PREPARED FOR THE PLAN COMMISSION

Project Address: 740 University Avenue
Application Type: Conditional Use
Legistar File ID # [36620](#)
Prepared By: Timothy M. Parks, Planning Division
Report includes comments from other City agencies, as noted.

Requested Action: Approval of a conditional use to allow construction of a music performance facility at 740 University Avenue on the University of Wisconsin–Madison campus.

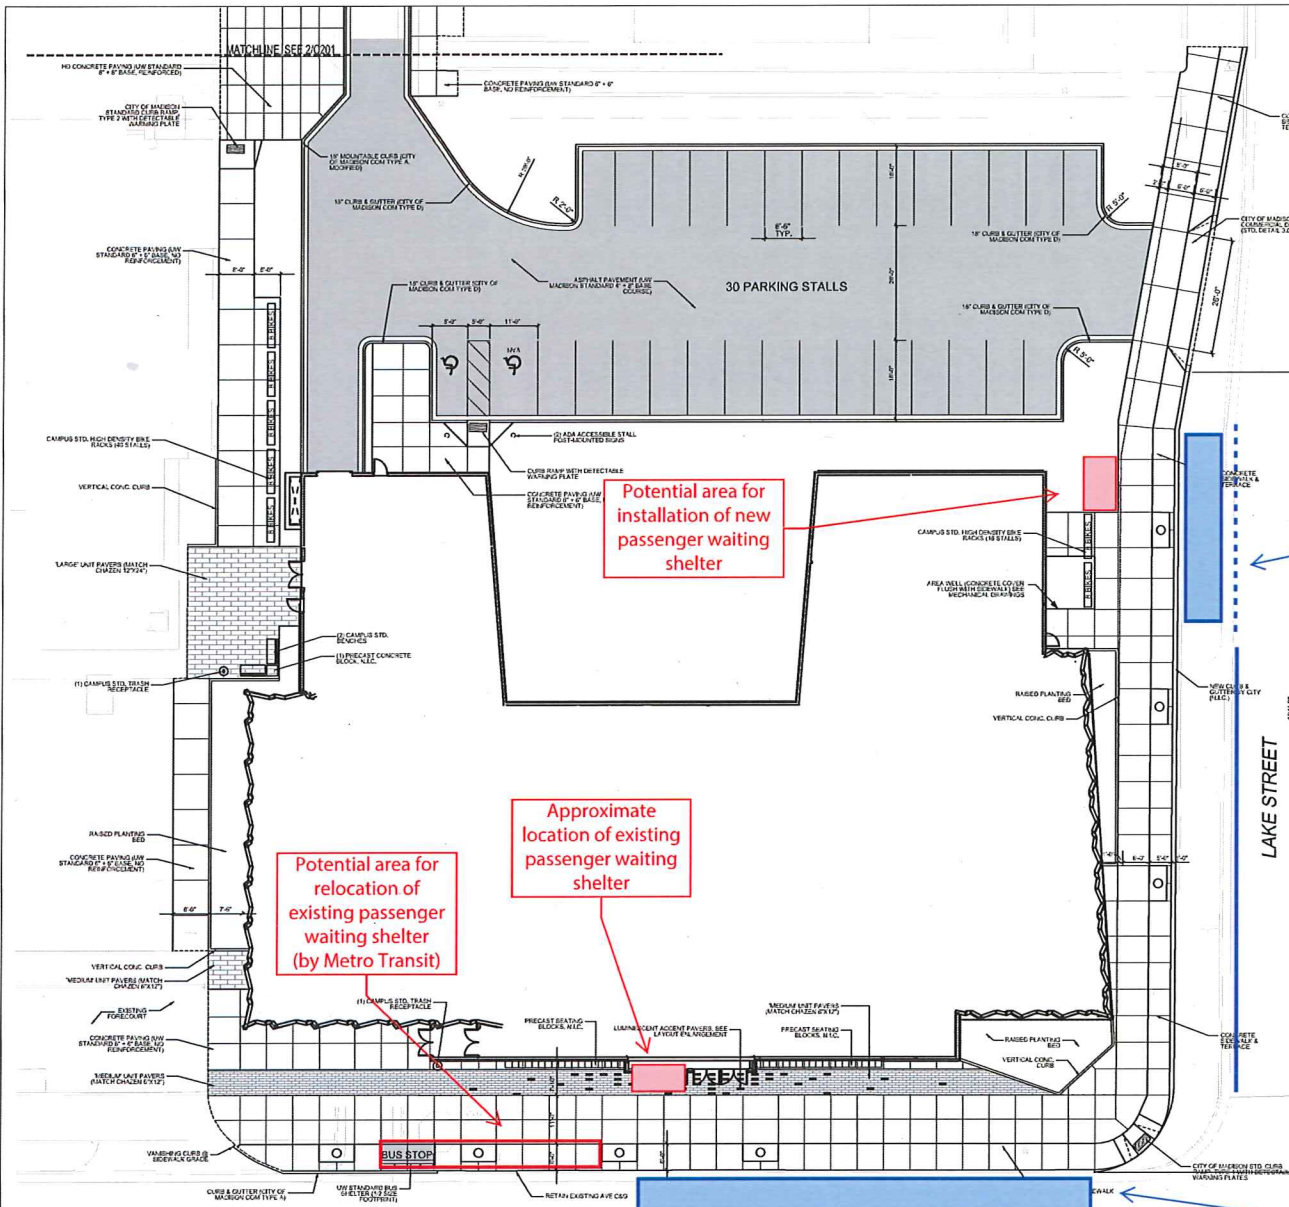
43. Forestry will permit the Elm removal closest to Fitch Court (newly planted), and the Ginkgo (poor condition) near the center of the University Avenue frontage. The removal of the elm closest to Lake Street on University Avenue will not be permitted until the developer provides information for why it needs to be removed. Approval and permitting of street tree removals shall be obtained from the City Forester and/or the Board of Public Works prior to final approval of the site plan. Please reference ID# 15107 when contacting Parks Division staff about this project.

METRO EXHIBIT

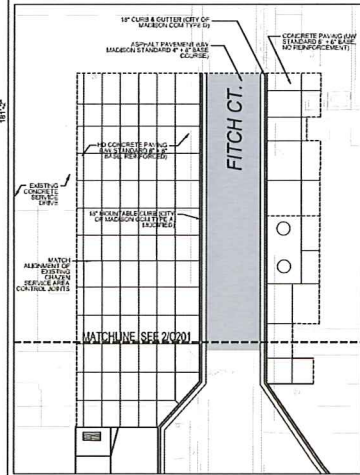
47. The applicant shall coordinate with Metro Transit staff the removal and relocation of the existing passenger waiting shelter on the north side of University Avenue, west of N. Lake Street, prior to construction.

49. The applicant shall install and coordinate the maintenance for a new passenger waiting shelter with seating amenity on the west side of N. Lake Street, north of University Avenue. The bus shelter should be installed a sufficient distance north of the intersection such that a stopped bus could depart the stop and proceed into the center through lane crossing University Avenue on southbound Lake Street. The applicant shall include the location of these transit amenities on the final documents filed with their permit application so that Metro Transit may review and approve the design.
